13 July 2016

Reference No. 1545831-007

CORONATION NORTH PROJECT CONSENT APPLICATION – S92 RESPONSES

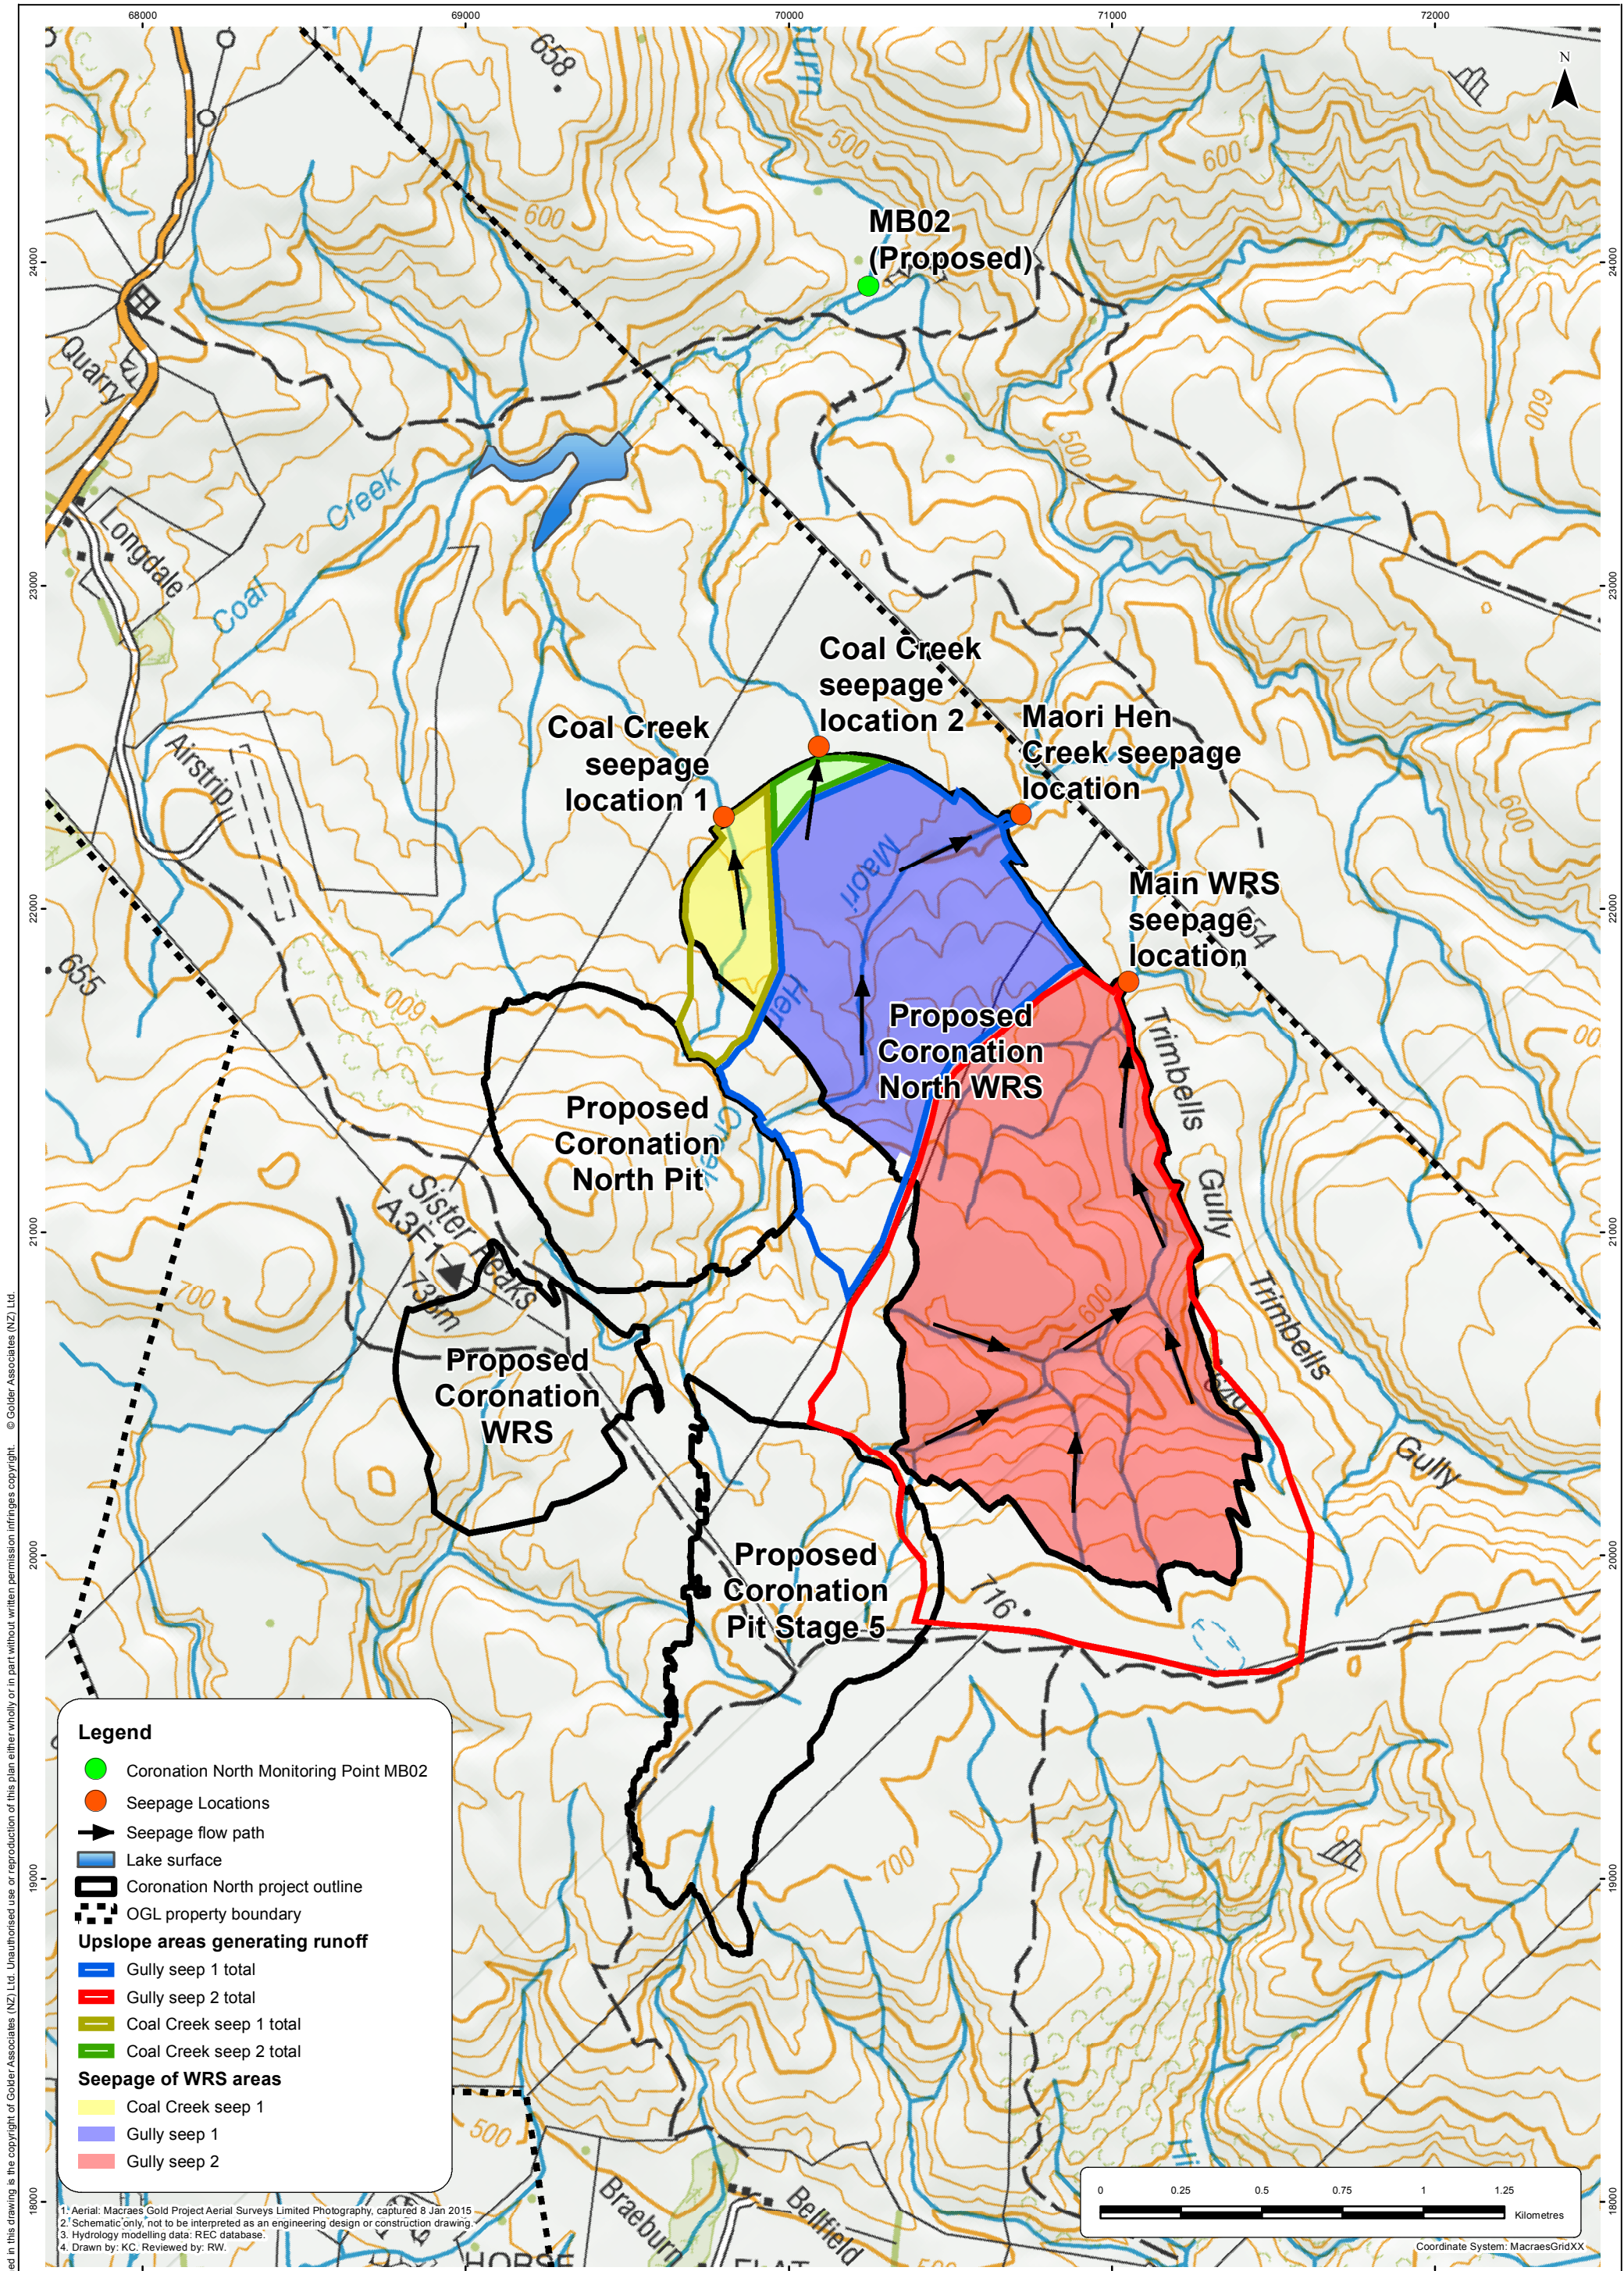
Council's preference, pursuant with Policy 6.5.5 (d) of the Regional Policy Statement for Otago, is to promote discharges to land where practical rather than to water bodies. Please provide comment on alternative methods of discharging.

The primary areas of mine water discharges from the proposed Coronation North Project are:

- 1) The toe of the Coronation North WRS in each of four gullies that contribute flows to Mare Burn (Figure 1).
- 2) The overflow points for the Coronation North Pit and the Coronation Stage 5 Pit.

Of the four WRS seepage discharge points, the two that contribute seepage flows to the Coal Creek catchment (Coal Creek seepage locations 1 and 2) are at elevations high enough in their respective sub-catchments that diversion of the flows to a land discharge could be considered. These discharges are however small compared to the overall site discharges (Table 1).

In terms of catchment areas available to accept discharges to land, only the discharge from Coal Creek seepage location 2 could be reasonably diverted via a race or pipeline to an adequate land disposal area, without the necessity for pumping. The other three WRS seepage discharges are located too deep in their respective gullies to enable diversion to suitable land irrigation areas without the need for ongoing pumping or the installation and maintenance of long pipelines to appropriate irrigation areas.

Figure 2: Turbidity data recorded from Deepdell Creek prior to 1994.

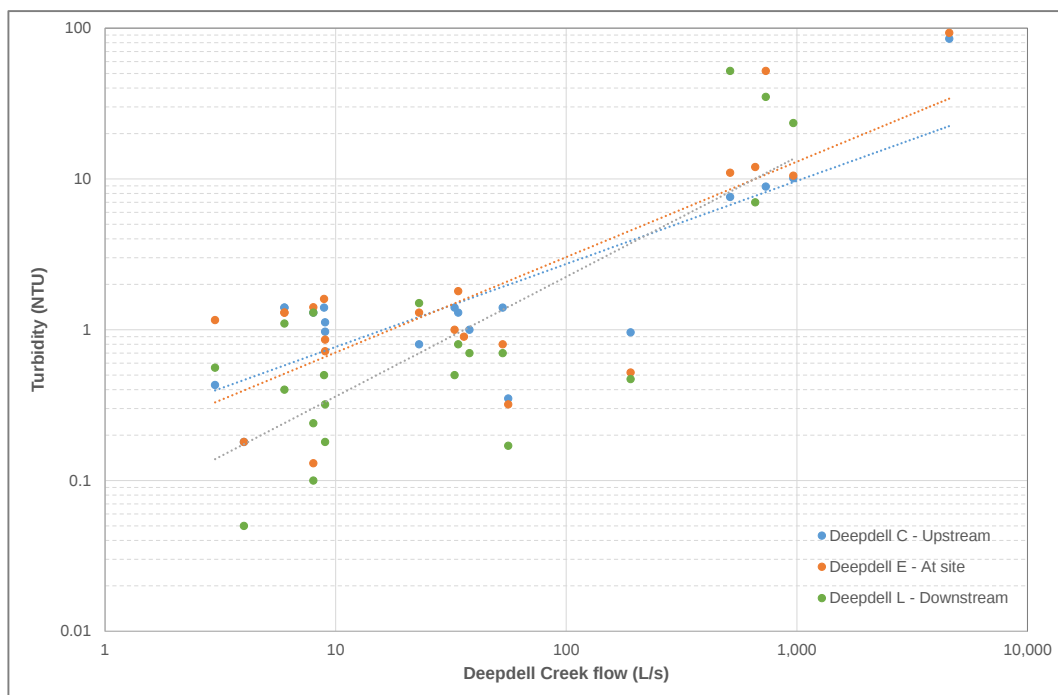
Provide background monitoring information on Mare Burn clarity (i.e., turbidity, suspended sediments, black disk clarity) to provide base flow and flood conditions.

OceanaGold has not carried out turbidity or suspended solids monitoring in Mare Burn and does not monitor either parameter on a regular basis at the Macraes Gold Project (MGP). Monitoring data from the early period of MGP development, prior to completion of the silt dam in Maori Tommy Gully downstream from the Mixed Tailings Impoundment, provides the best indication of potential turbidity levels in the Mare Burn under a range of flow regimes (Figure 2).

Figure 3: Nitrate nitrogen concentrations recorded from Deepdell Creek downstream from the MGP (DC07 and Deepdell_L).

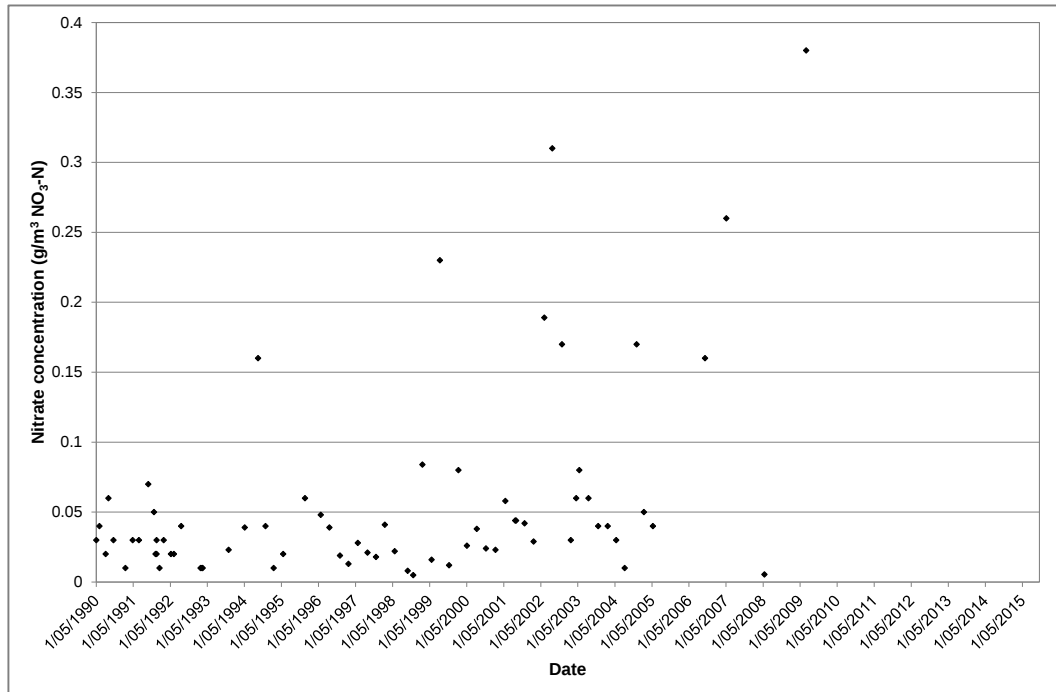
Provide background monitoring information on Mare Burn nutrient (nitrogen and phosphorus) concentrations under base flow and flood conditions.

Nitrate nitrogen concentrations recorded at equivalent downstream compliance points in Deepdell Creek are presented in Figure 3, with the TN concentrations for the same monitoring points presented in Figure 4.

Background sampling for nitrate nitrogen has been done only four times since 1994, with a maximum concentration of 0.21 g/m³ detected. Eleven background samples have been analysed for TN since 2006, with the results mostly being for concentrations less than 0.05 g/m³.

Figure 6: Electrical conductivity recorded from Mare Burn at MB01 and MB02.

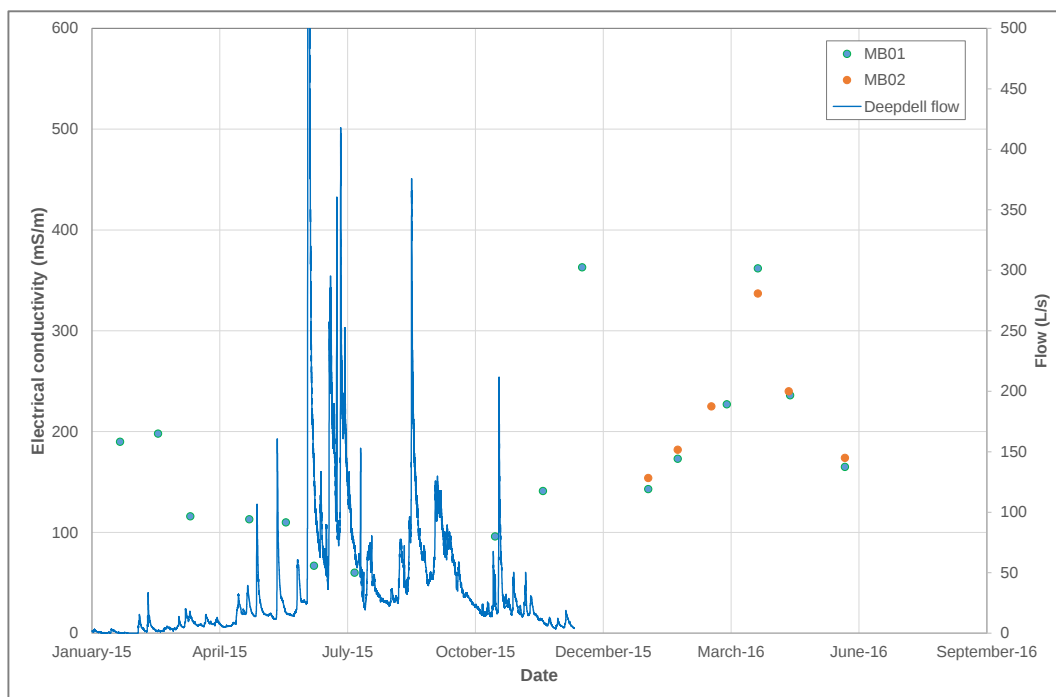
Provide background monitoring information on Mare Burn electrical conductivity and sulphate concentrations under base flow and flood conditions.

OceanaGold monitors both electrical conductivity (Figure 6) and sulfate (Figure 7) concentrations in Mare Burn at both MB01 and MB02 monitoring points on a monthly basis. Monitoring started at MB01 in January 2015 and at MB02 in February 2016. Given the short period of record, there is insufficient data available to characterise the quality of water in Mare Burn under different flow conditions. The information available to date is provided below.

Figure 8: Change in turbidity data recorded from Deepdell Creek prior to 1994.

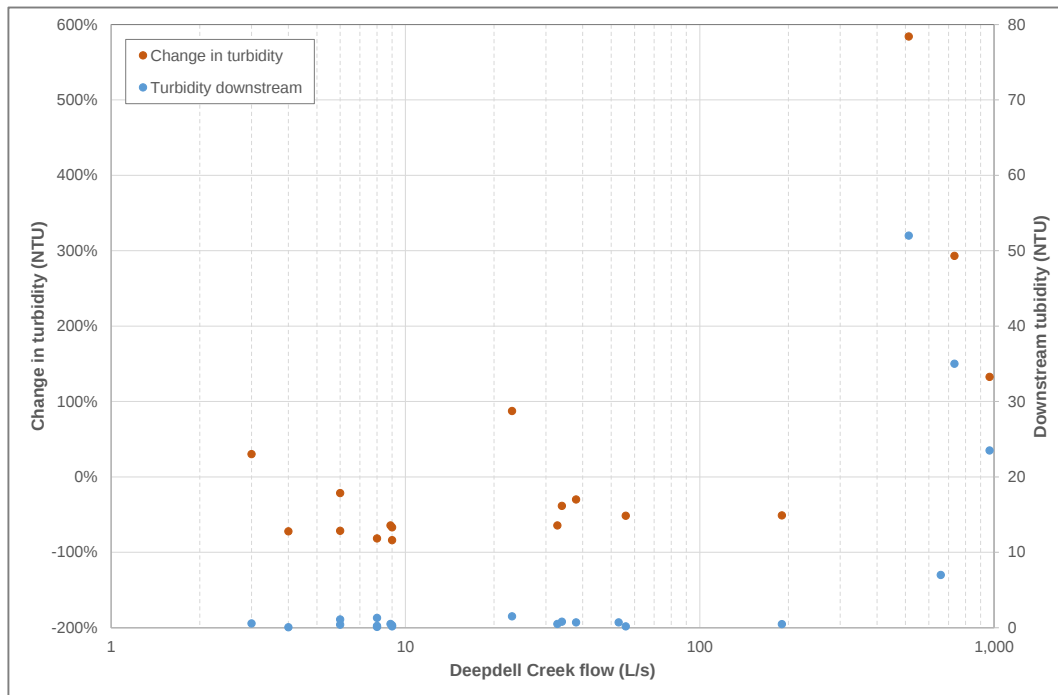
- 12: *Provide information on predicted suspended sediment and turbidity levels in pit lake and at downstream compliance sites.*
- 13: *Provide an updated assessment of compliance with the NPS FW standards for nitrate and ammoniacal-N at site MB02. This assessment should include an add to background approach to establish predicted concentrations downstream of the monitoring site.*

As previously noted in this letter, OceanaGold does not routinely monitor suspended sediment concentrations or turbidity at most compliance monitoring points at the MGP. The most relevant data can be derived from Deepdell Creek monitoring during the early development period of the MGP, with this data previously presented in Figure 2. Under most low-flow conditions turbidity recorded from Deepdell Creek prior to 2004 decreased from upstream to downstream (Figure 8). Under higher (but not flood) flows the turbidity increased from upstream to downstream of the MGP, however the number of records is too small to confirm any trend.

Figure 9: Coronation North Project flow duration results – normal scale (all stages).

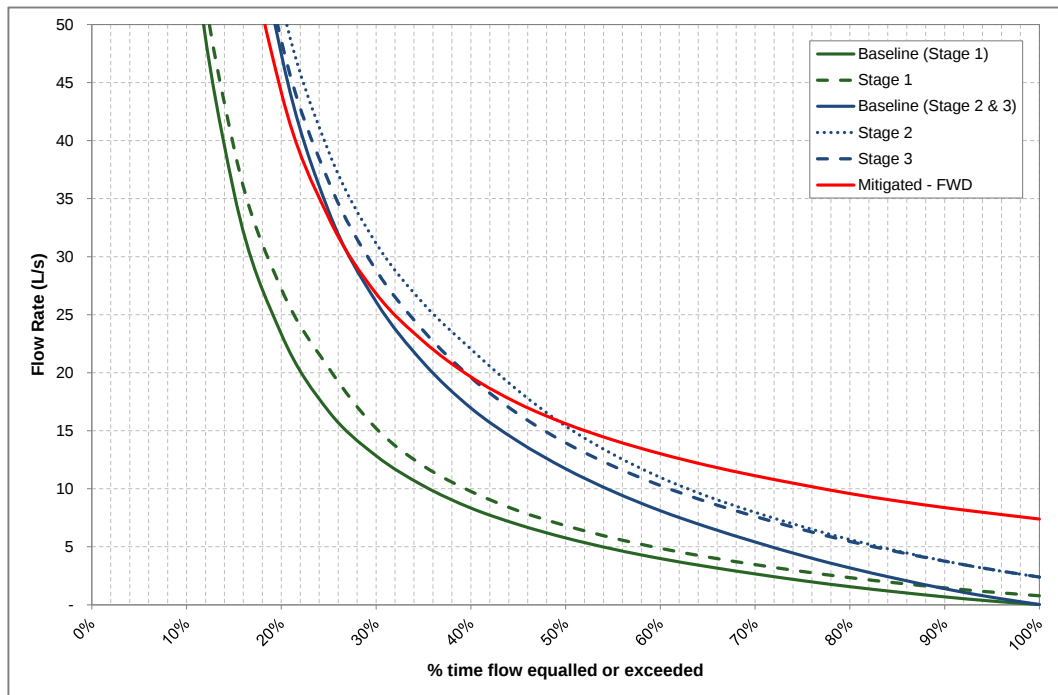
Provide flow hydrographs for: (i) site MB01; (ii) MB02 (existing); and (iii) MB02 after freshwater dam inflows.

The model logic diagrams and supporting information are documented in the surface water report⁷. The outcomes of the modelling are summarised as flow duration curves in Figure 9 (normal vertical scale) and Figure 10 (log vertical scale). A statistical summary of the projected Mare Burn hydrology under different stages of mine development is provided in Table 20 of the surface water report, together with the supporting documentation.

Figure 13: Average monthly rainfall and pan evaporation for Macraes Gold Project.

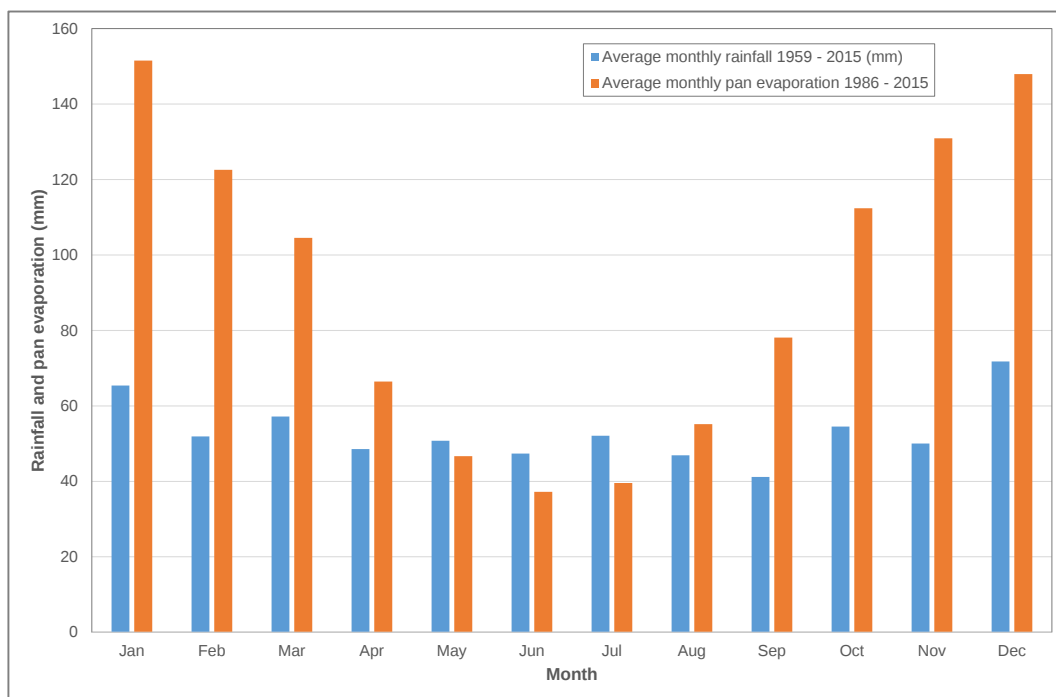
Provide further information on the seasonality of the "water deficit" for the stormwater management. Will this just be in summer or a whole year deficit?

There available monitoring data used to support development of the Coronation North surface water model⁷ are summarised as average monthly rainfall and pan evaporation in Figure 13. The pan evaporation deficit extends for much of the year. This deficit does however not mean that there is insufficient yield from the Coal Creek catchment to provide for a continuous discharge of 5 L/s from the planned Coal Creek dam.
